APPLICATION FOR CERTIFICATE OF APPROPRIATENESS (COA)

Building address 327 Broadway Bethlehem, PA 18015

The February submission addresses the concerns of the board regarding the 4th Street facade, and includes some new additions as the overall building program is developed. At the start of this project, we sought approval for renovations related to the Seven Sirens Brewery to be located on the first level of 327 Broadway. As the project has evolved over the past several months, the scope has grown to include renovations to the upper two levels and roof. Items approved in prior submissions have been omitted and left unchanged. The attached drawings highlight only newly developed items and open (unapproved) items. The items below are included in this submission:

PROJECT
Seven Sirens
Brewery
327 Broadway
Bethlehem, PA
18015

2
North Elevation
1/16" = 1'

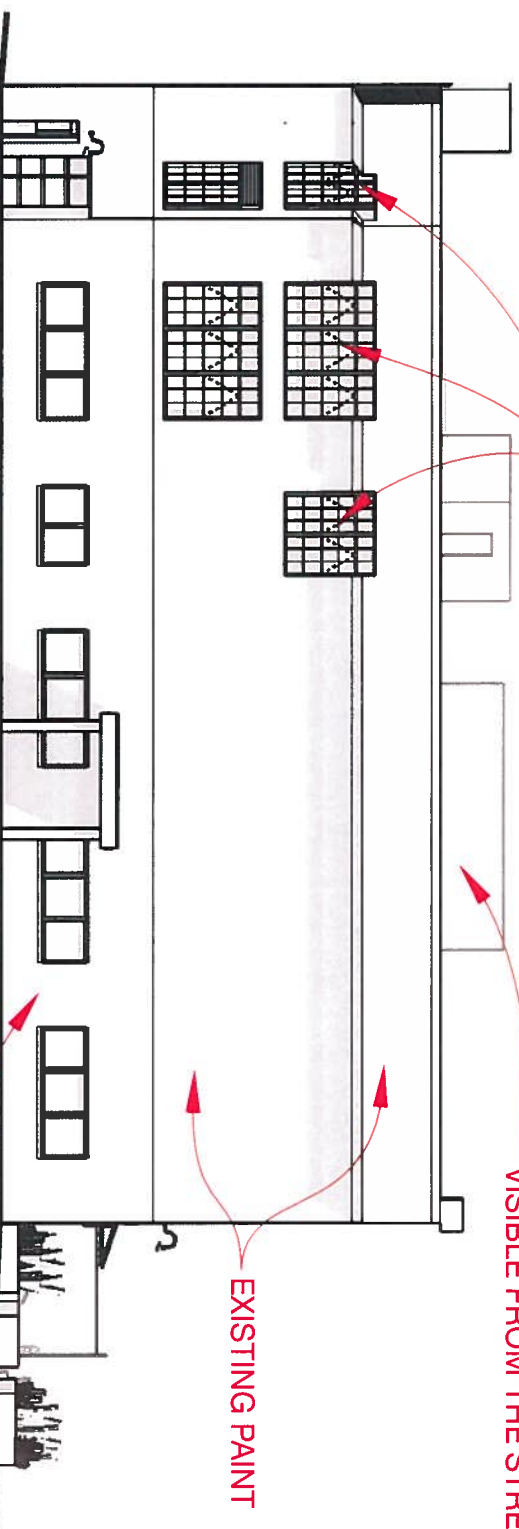
UPDATED PER COMMENTS, SEE
ENLARGED ELEVATION, NEXT
SHEET

1 Proposed North Elevation (4th Street)

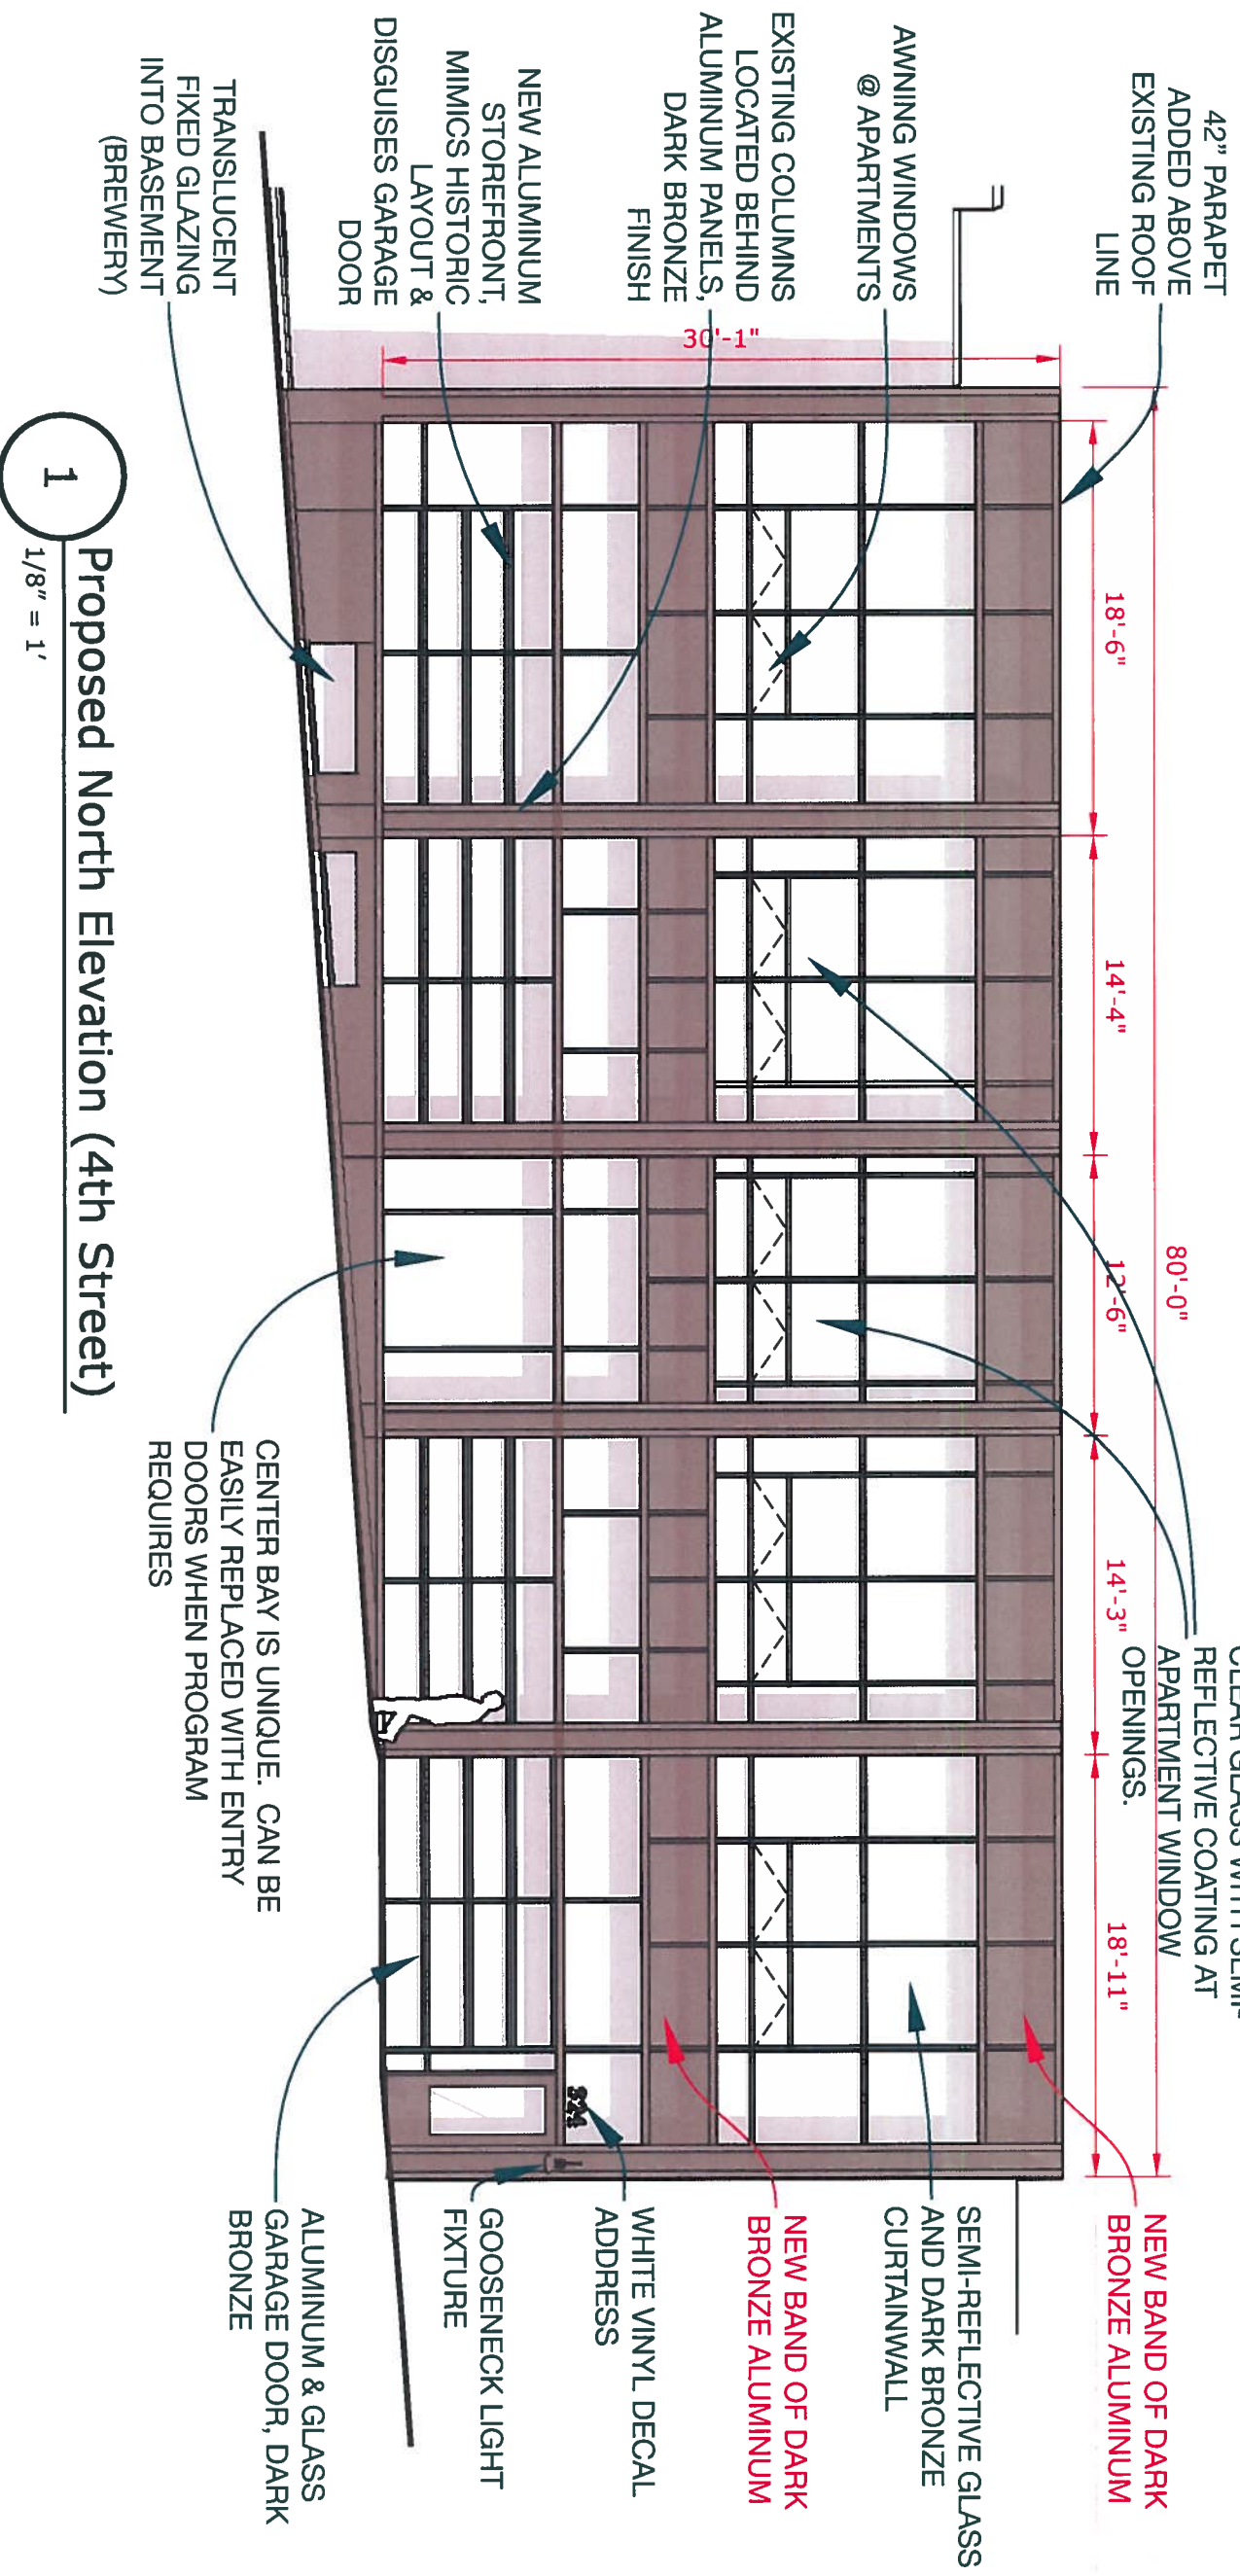
COMMENTS FROM PREVIOUS MEETINGS:

1. Add horizontal bands of contrasting color/material to reflect historic divisions in facade **RESPONSE:** Two rows of horizontal opaque aluminum panels have been added in place of spandrel glass. These roughly mimic the proportions and location of the decorative cornices of the original facade.
2. Reflective Glass is generally not acceptable **RESPONSE:** Glass samples will be provided at meeting. Glass is only slightly reflective, not tinted or mirrored.
3. Normalize or align vertical divisions of glass panels. **RESPONSE:** Divisions at the two "cornices" have been shifted to align with window openings above or below. Verticals at second floor are aligned with existing masonry openings. Verticals at first floor are consistent with historic divisions.
